**A RESOLUTION AUTHORIZING A CONTRACT EXTENSION WITH R.J. WATKINS AND SON CONSTRUCTION, INC. FOR ADDITIONAL SERVICES RELATED TO THE NORTHBOUND RIGHT TURN LANE CONSTRUCTION AT COMMONWEALTH AND MAIN STREET**

SUBJECT: Contract Extension with R. J. Watkins and Son Construction, Inc. for extra rotomilling work as requested by the Tennessee Department of Transportation

**RIGHT TURN LANE ADDITION &  
 PEDESTRIAN SIGNALIZATION IMPROVEMENTS  
 ALONG MAIN STREET (HWY 31) - CONTRACT A**

DATE: DECEMBER, 2017  
 APRIL 26, 2018 ADDED ADDITIONAL  
 MILLING AND PAVING PER TDOT

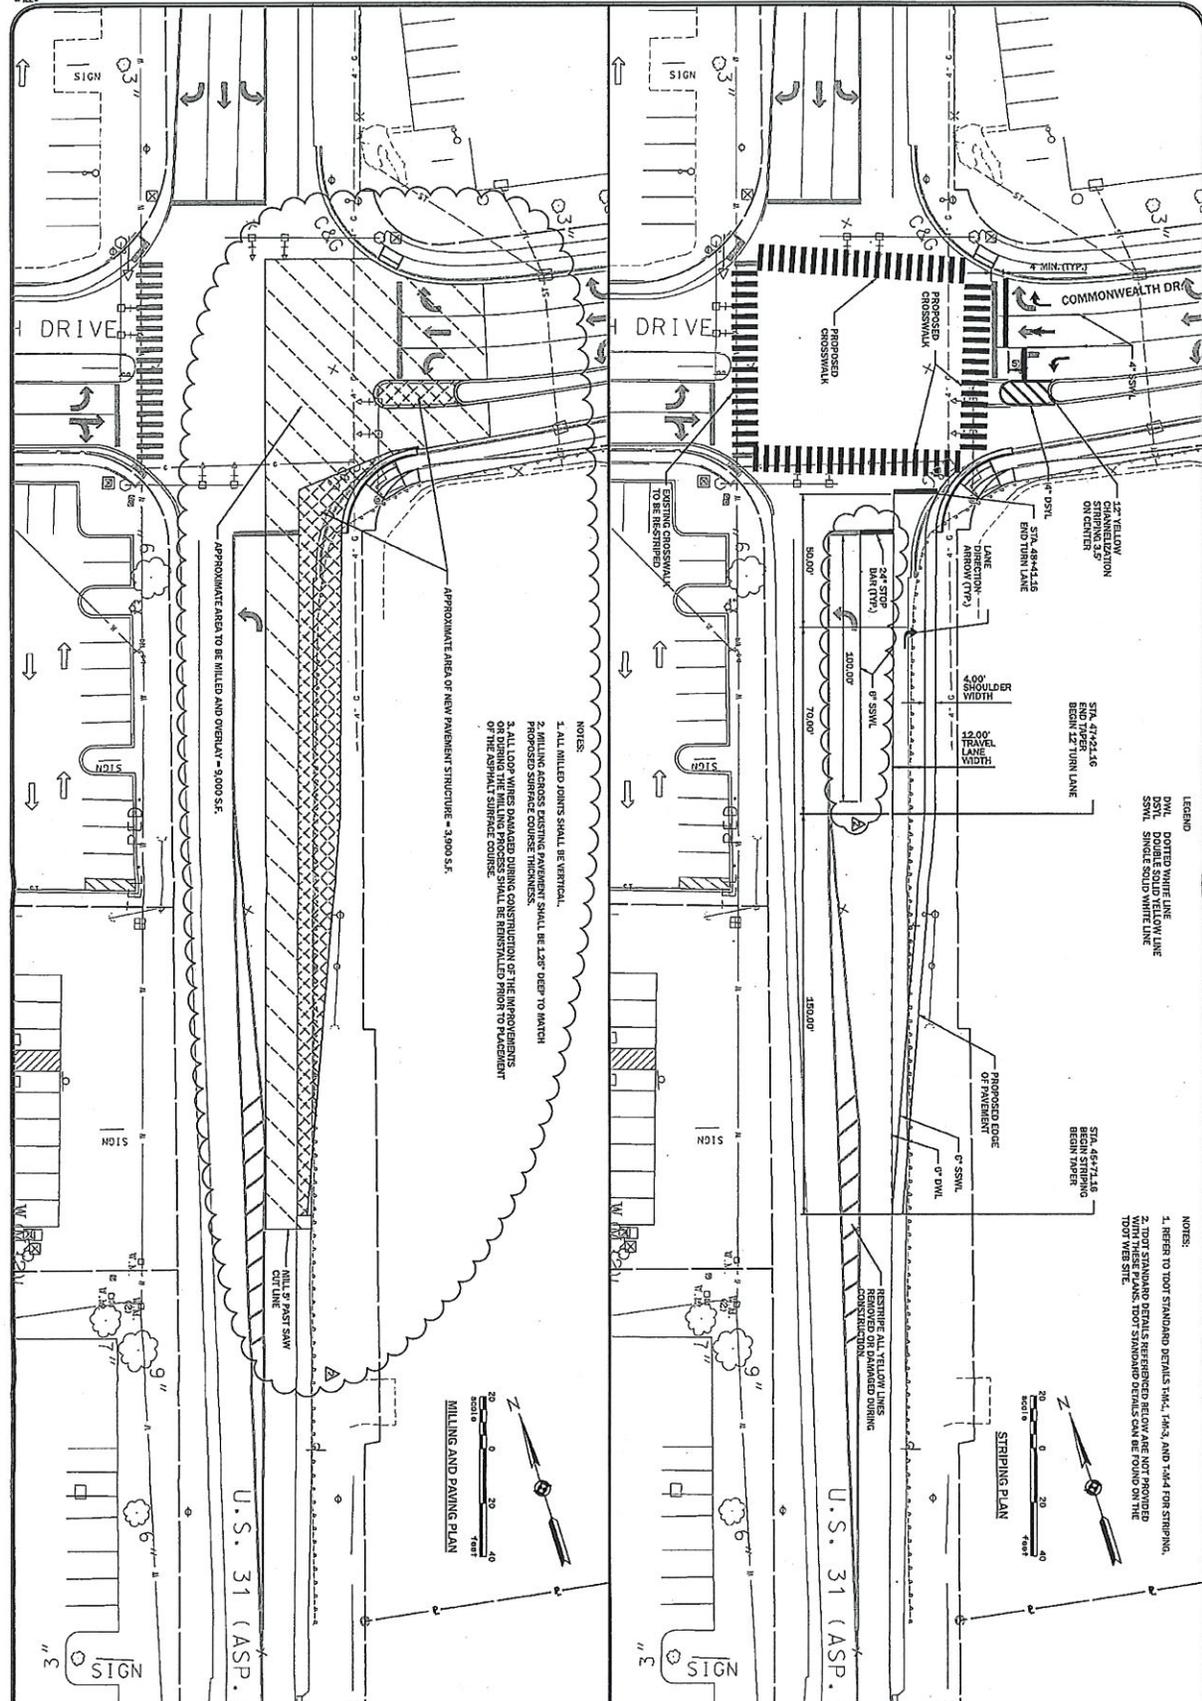
TDOT is going to require the milling and overlay of the adjacent lane of traffic. As a result, I have attached a full revised set of plans showing this additional work. We are formally requesting a Lump Sum Change Order Price to complete the additional work.

Saw slot and loop wire is still estimated as a lump sum price, but there is the potential to have to redo some of the loops on Main Street now with the additional milling. With the additional milling, we will go ahead and mill back on Commonwealth which will eliminate the striping removal line items. The line items impacted by this change include the following:

I spoke with my District Engineer and you have to overlay **one full lane** width over. Not just one foot past the joint. We do typically do overlay the entire roadway, but since this a recently paved section they will make that compromise. Please feel free to call if you have any questions.

ESTIMATED ROADWAY QUANTITIES FOR THE TURN LANE AT COMMONWEALTH DR.				
ITEM NO.	DESCRIPTION	UNIT	Old QTY	New Qty
403-01	BITUMINOUS MATERIAL FOR TACK COAT (TC)	TON	0.14	0.40
411-02.10	ACS MIX (PG70-22) GRADING D	TON	35.00	95.00
716-02.05	PLASTIC PAVEMENT MARKING (STOP LINE)	L.F.	55.00	68.00
716-08.01	REMOVAL OF PAVEMENT MARKING (LINE)	L.F.	9.00	0.00
716-08.05	REMOVAL OF PAVEMENT MARKING (STOP LINE)	L.F.	37.00	0.00
716-08.06	REMOVAL OF PAVEMENT MARKING (TURN LANE ARROW)	EACH	2.00	0.00
716-08.07	REMOVAL OF PAVEMENT MARKING (STRAIGHT ARROW)	EACH	1.00	0.00
716-12.02	ENHANCED FLATLINE THERMO PVT MRKNG (6IN LINE)	L.M.	0.03	0.05
920-10.05	SAW SLOT & LOOP WIRE	LS	1.00	1.00
<b>NOTE:</b>				
THE QUANTITIES LISTED ABOVE ARE ESTIMATED QUANTITIES OF THE WORK NECESSARY TO COMPLETE THE PROPOSED IMPROVEMENTS. THE CONTRACTOR IS SOLELY RESPONSIBLE TO VERIFY ALL QUANTITIES AND ENSURE ALL NECESSARY COSTS ARE INCLUDED IN THEIR LUMP SUM BID PRICE. CHANGE ORDER PRICE SHALL INCLUDE ALL WORK NECESSARY TO COMPLETE THE WORK IN ACCORDANCE WITH THE REVISIONS SHOWN ON THE PLANS.

**PROPOSED LAYOUT**  
2017 ROADWAY IMPROVEMENTS  
TURN LANE AND PEDESTRIAN CROSSWALKS  
CITY OF SPRING HILL  
WILLIAMSON COUNTY, TENNESSEE

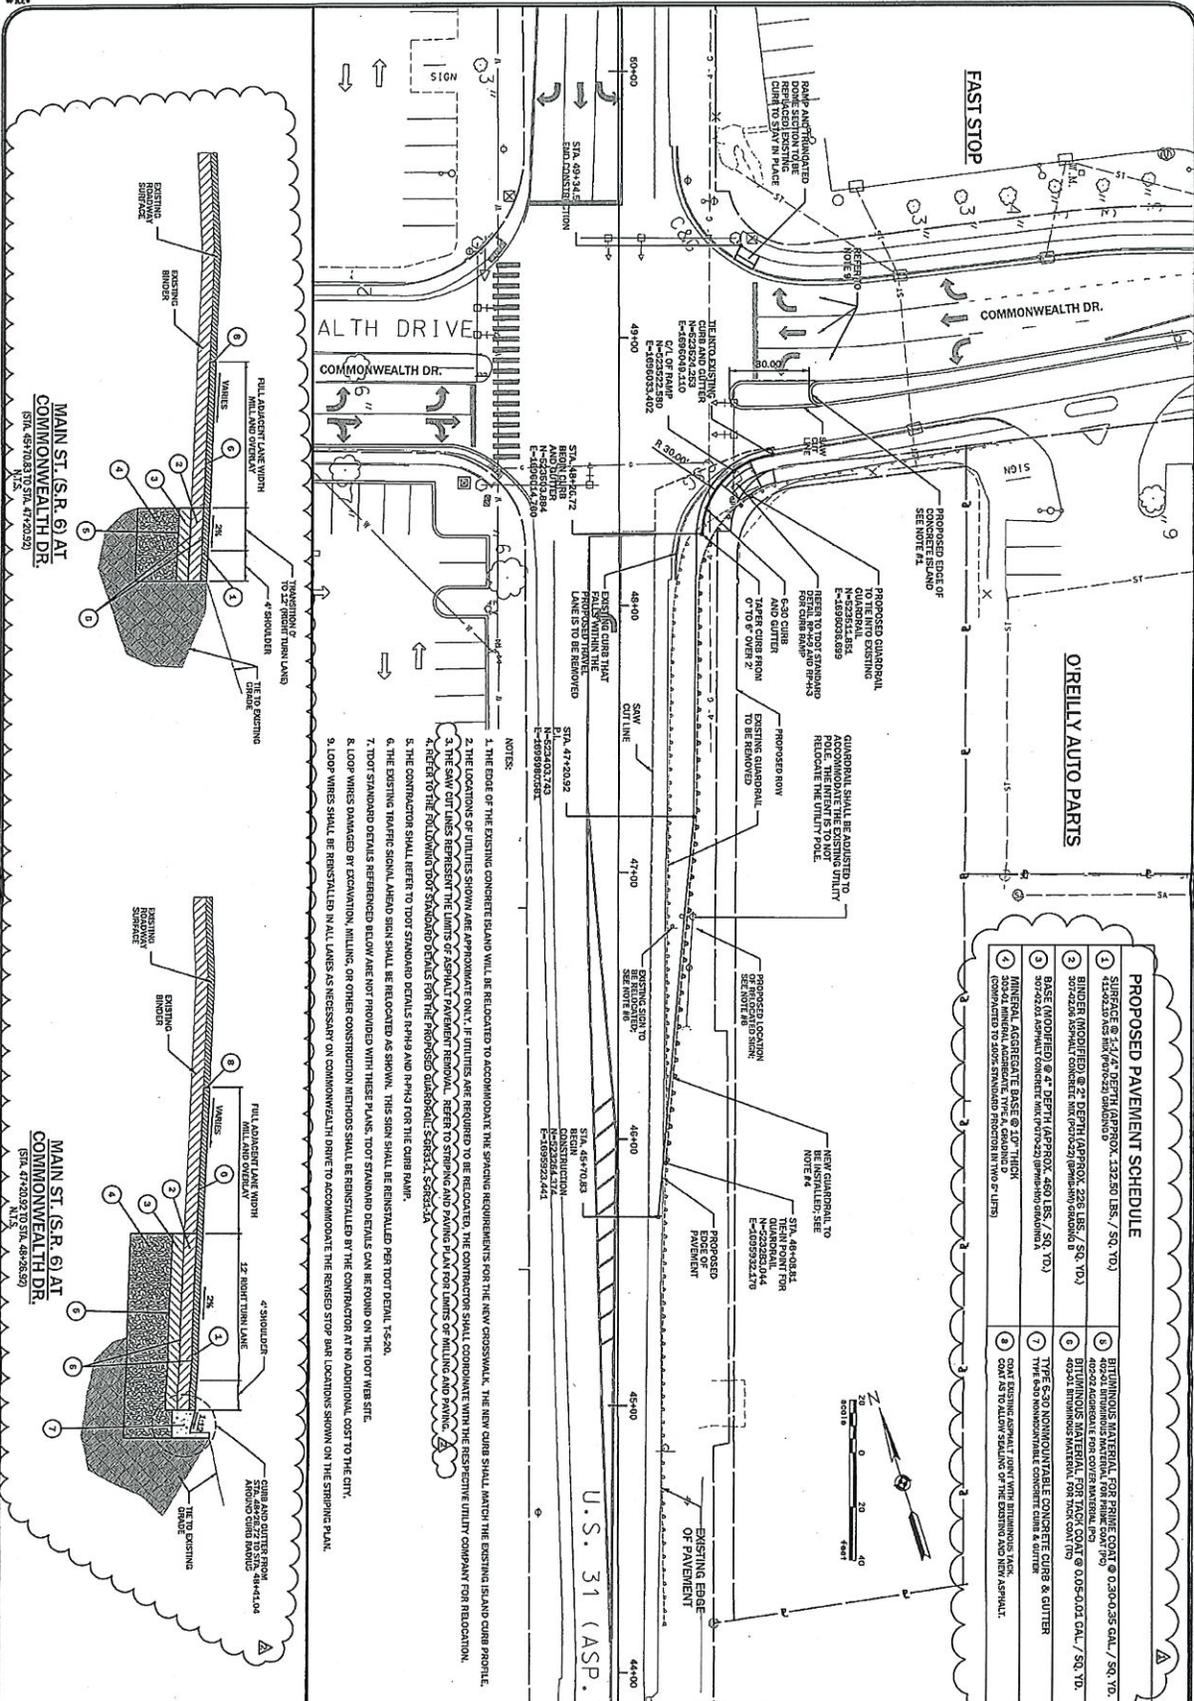
Attached is the Layout Sheet with the revised pavement section. Please let me know where to send the revised hard
